Regulation No. 105 (ADR vehicles)

Proposal for the 06 series of amendments to Regulation No. 105 (ADR vehicles)

Note by the secretariat *

Model A
(see paragraph 4.4. of this Regulation)

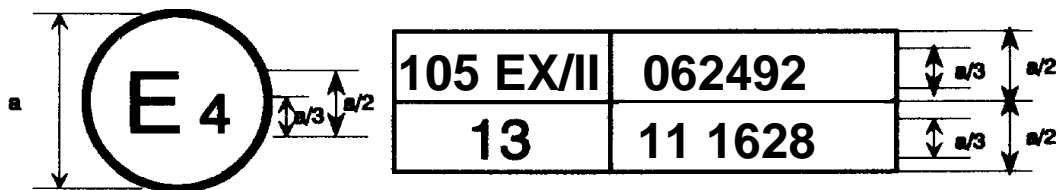
Annex 2, amend to read:

The above approval mark affixed to a vehicle shows that the vehicle type concerned, intended for the transport of dangerous goods, has been approved in the Netherlands (E 4), pursuant to Regulation No. 105, under the approval number ~~052492~~ **062492** and designated EX/II (according to paragraph 9.1.1.2. of Annex B to the ADR). The first two digits of the approval number indicate that the approval was granted in accordance with the requirements of Regulation No. 105 as amended by the ~~05 06~~ series of amendments.
